737

Service Bulletin

Number: 737-28A1206
Original Issue: January 11, 2006
Revision 2: May 21, 2009
ATA System: 2822 3152

SUBJECT: FUEL - Distribution - Center Fuel Tank Boost Pump Auto Shutoff and Master Caution Logic Change

FIGURE 33: W0040 WIRE BUNDLE ROUTING

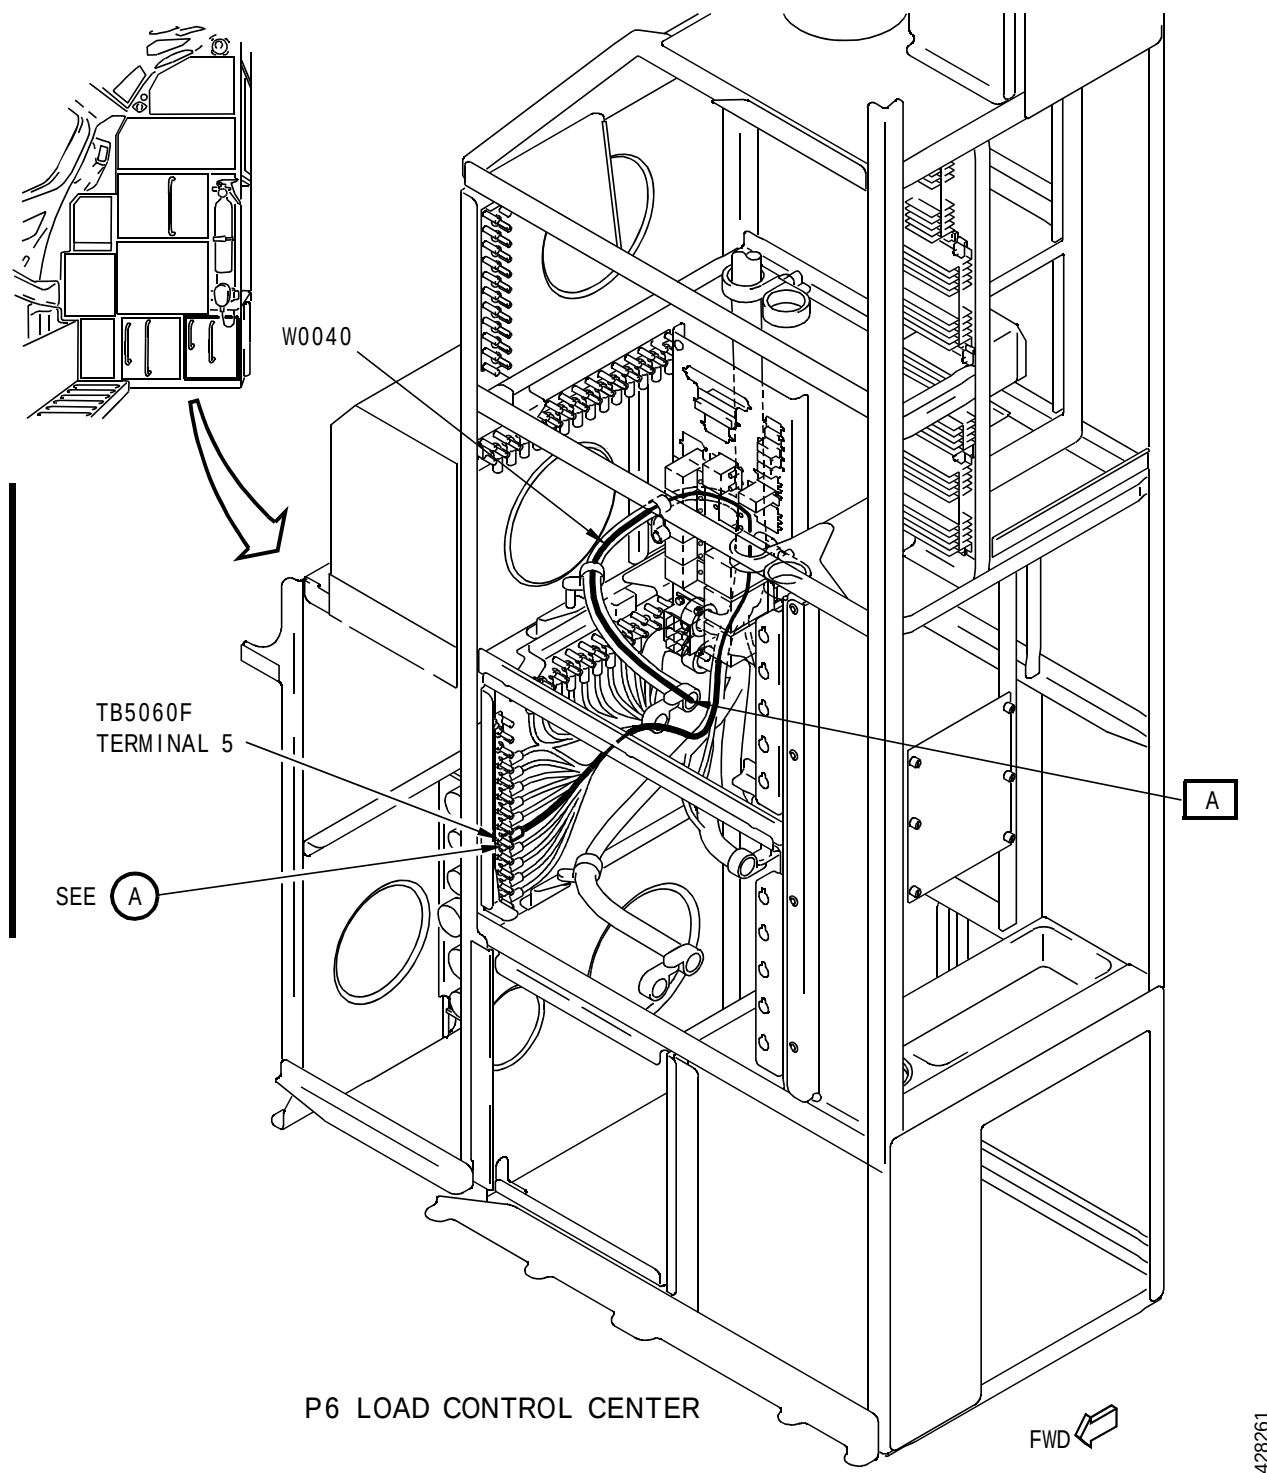
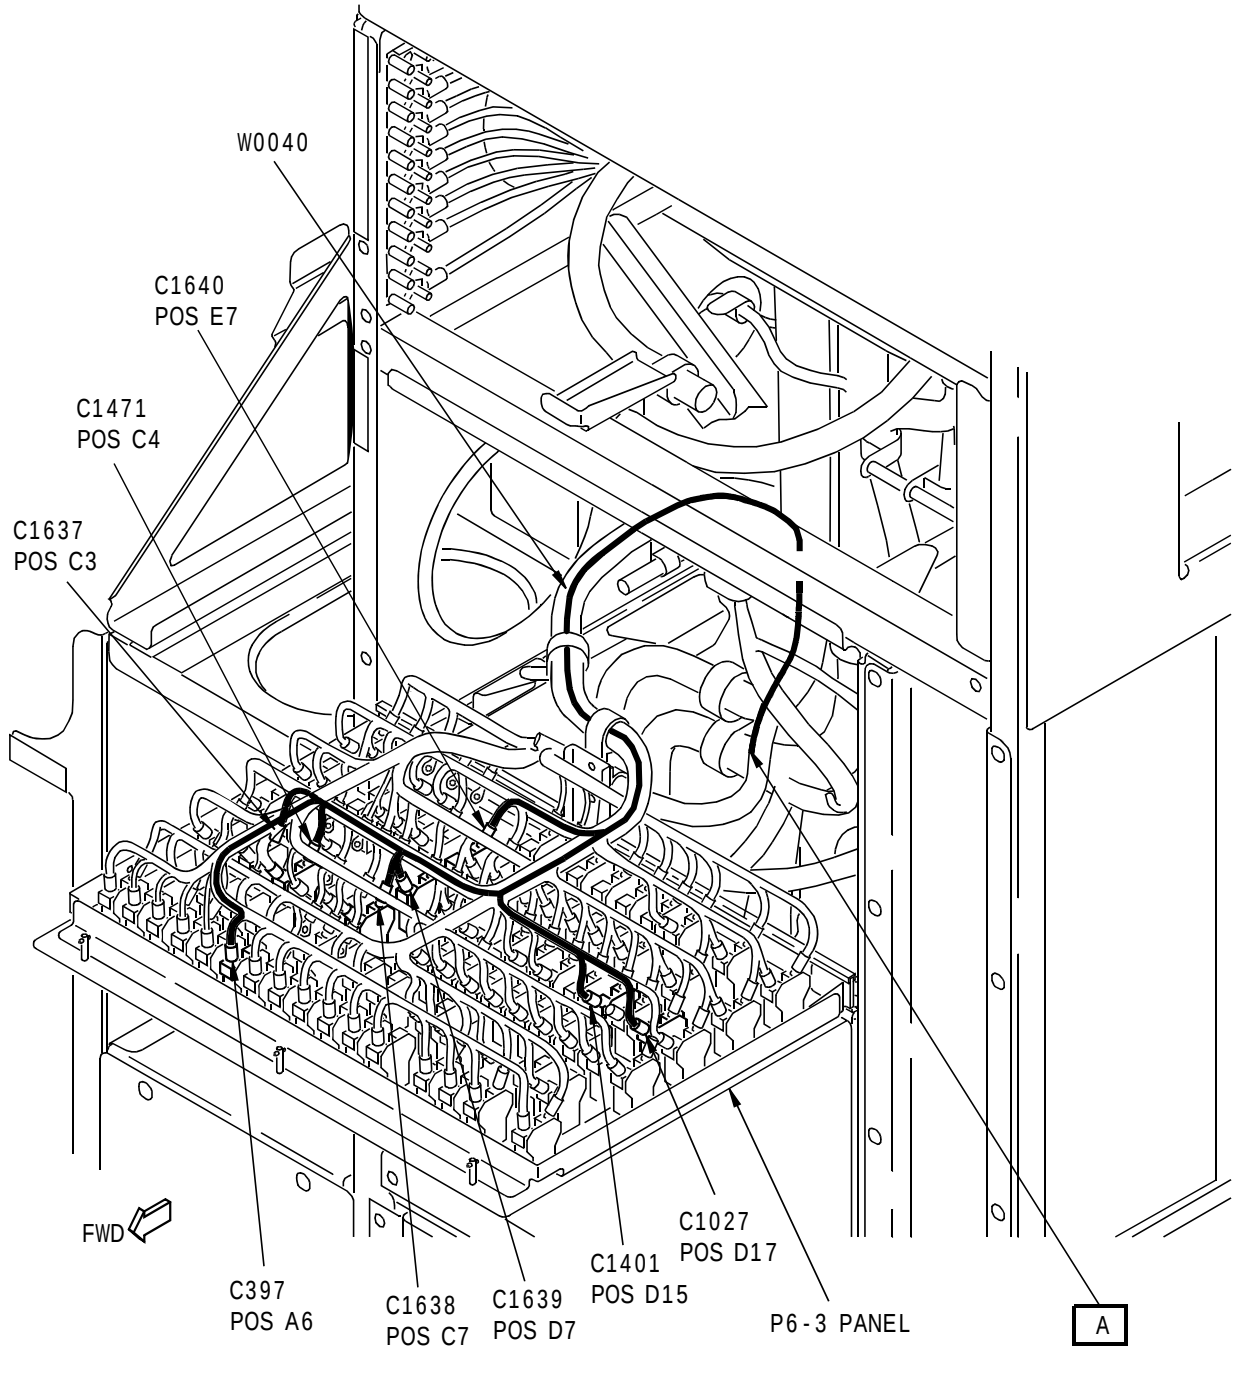
Figure 33 - Changes are made to show the correct the location of Terminal 5 and to add a detail with Terminal Block TB5060F.

Changes are made to Figure 33 to add a title to the Figure to clarify the location shown.

FIGURE 35: W0040 WIRE BUNDLE ROUTING

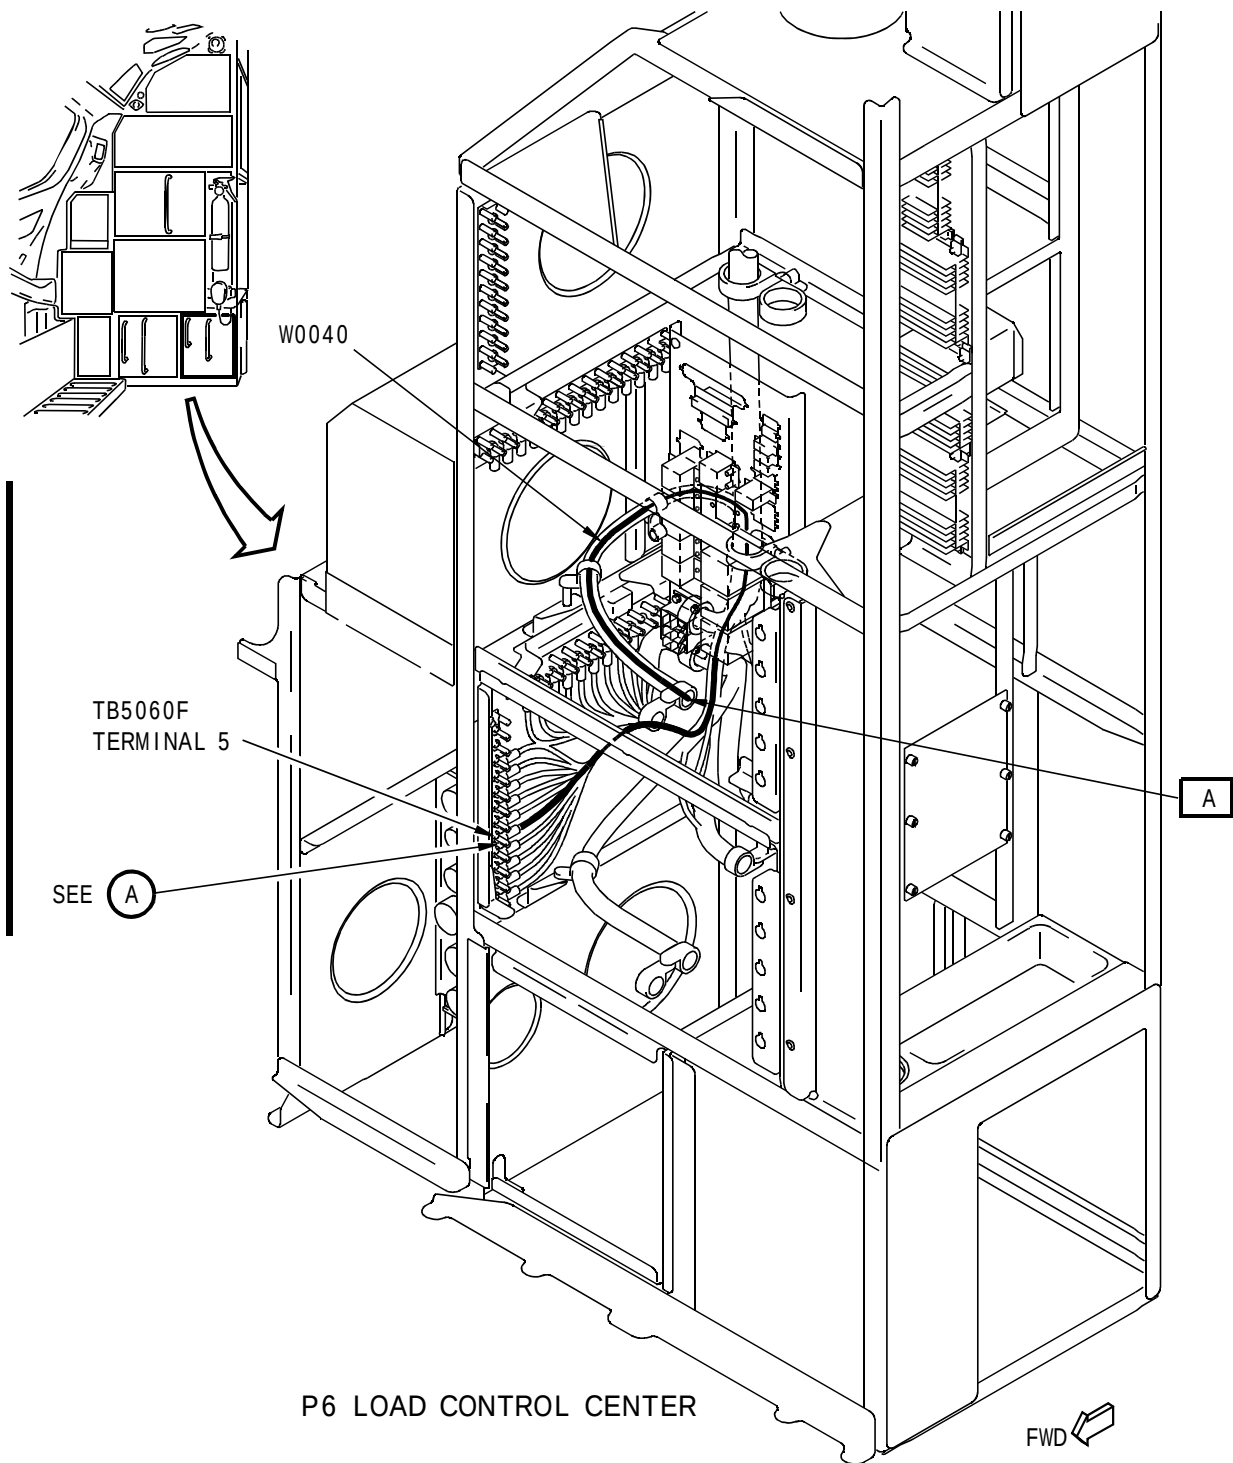
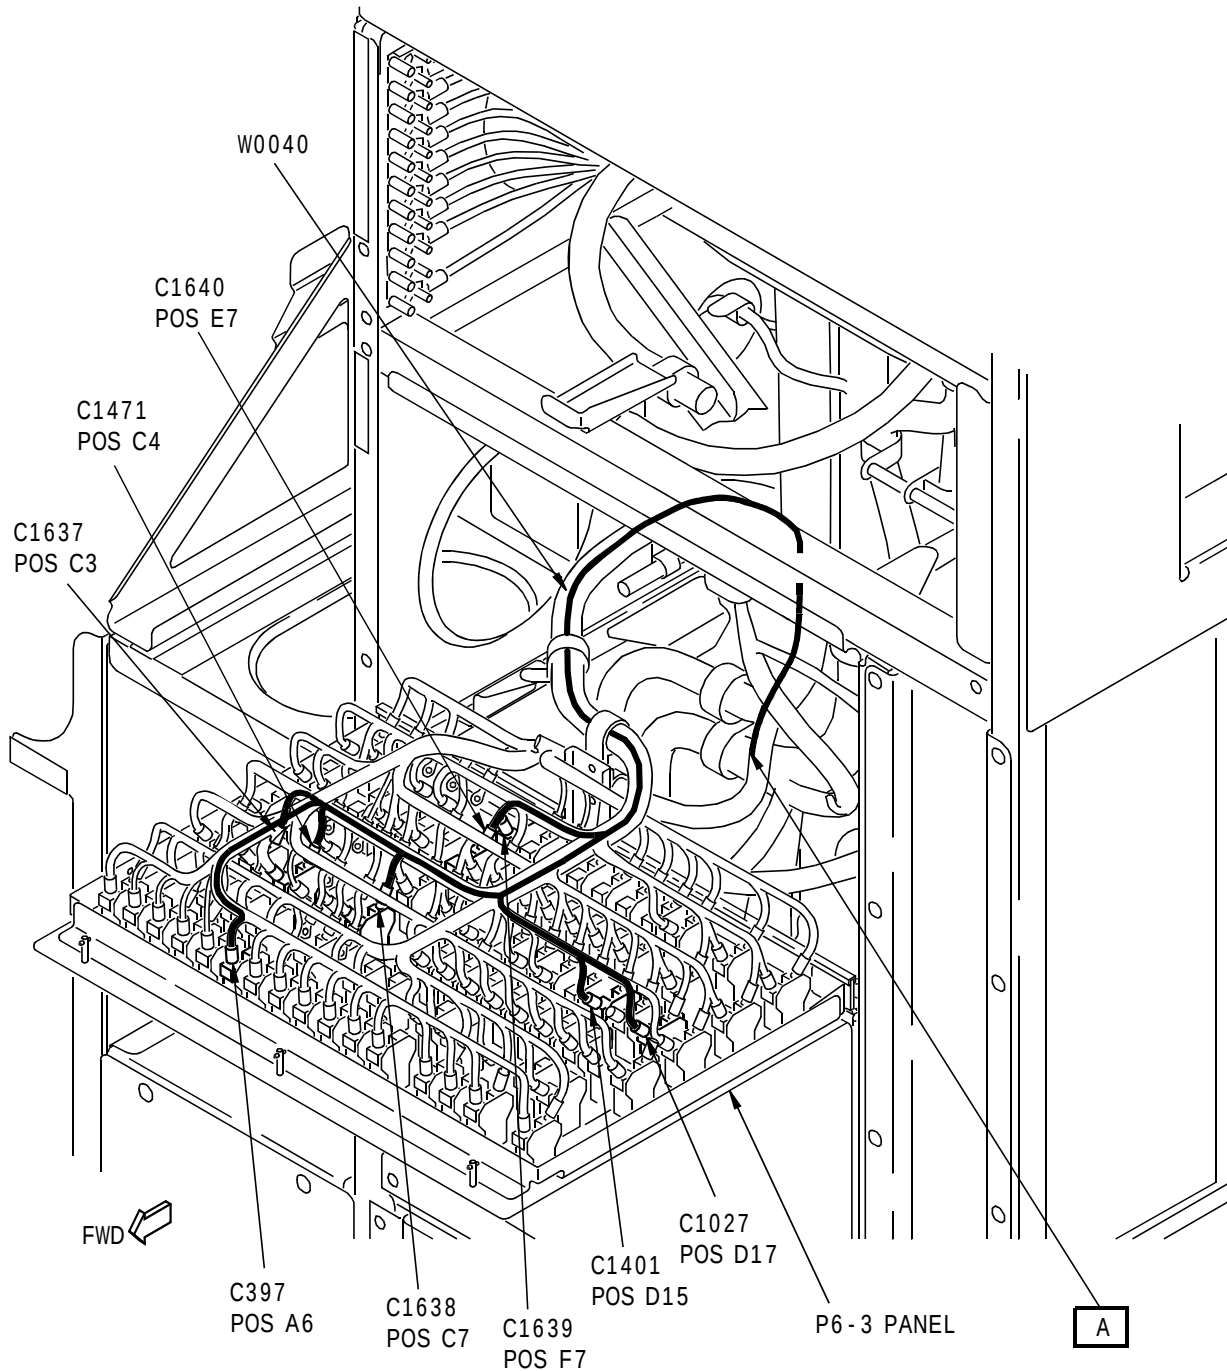
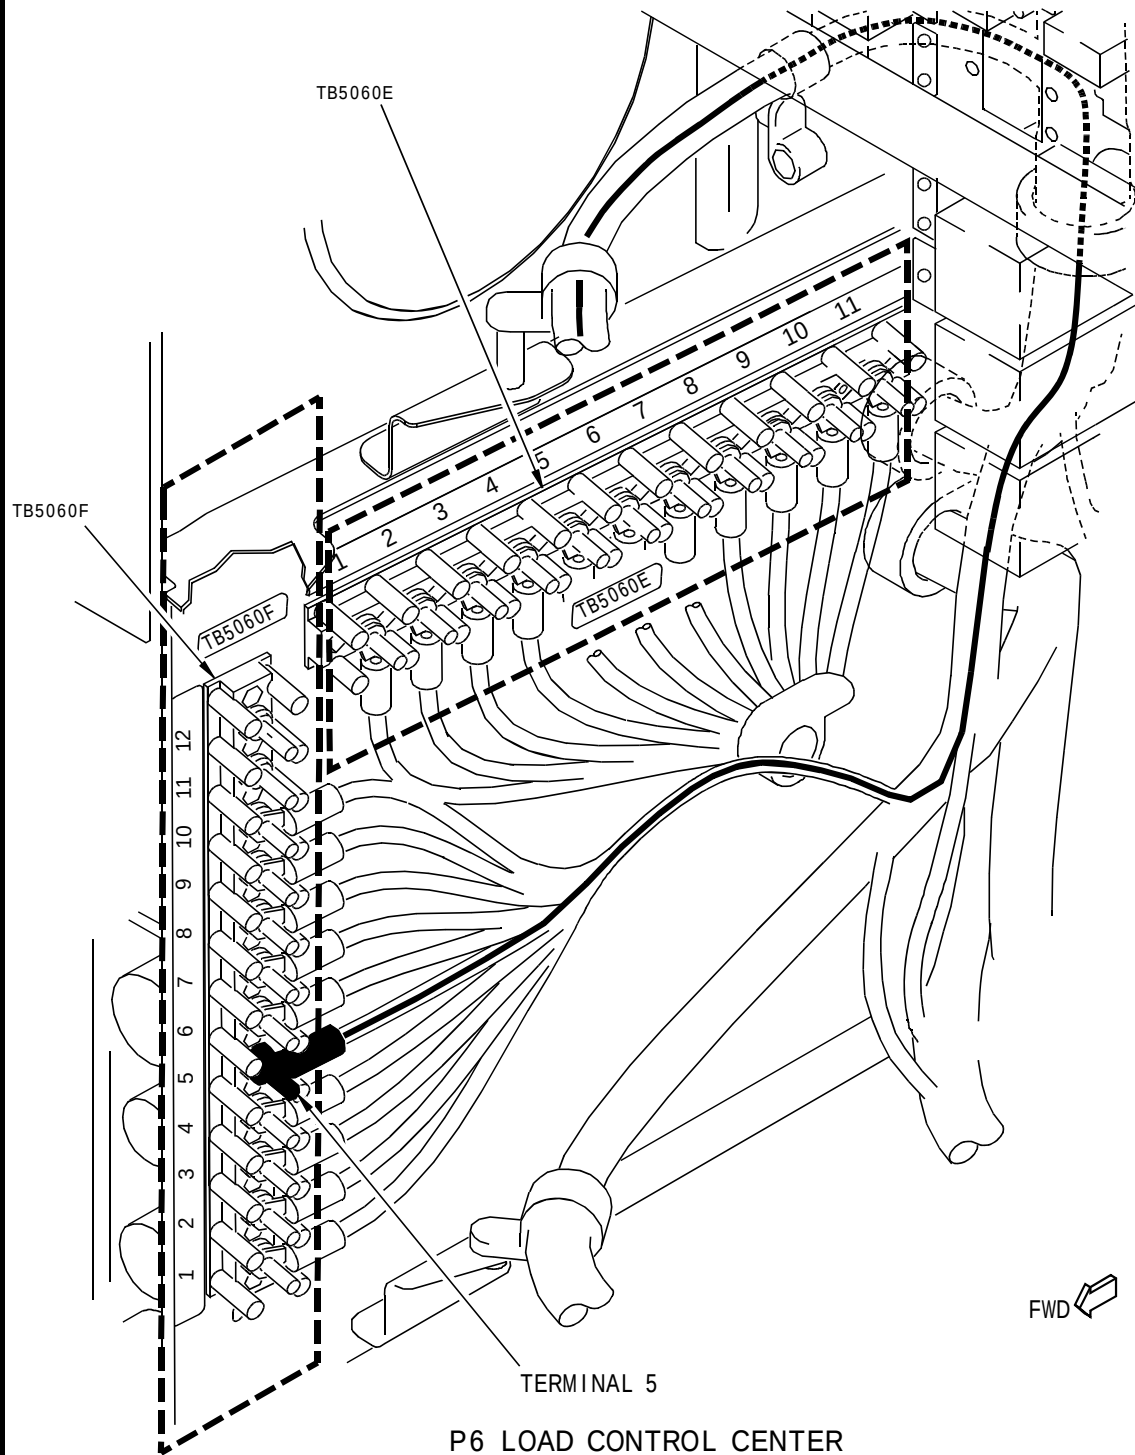
Figure 35 - Changes are made to show the correct location of Terminal 5 and to add a detail with Terminal Block TB5060F.

Changes are made to Figure 35 to add a title to the Figure to clarify the location shown.
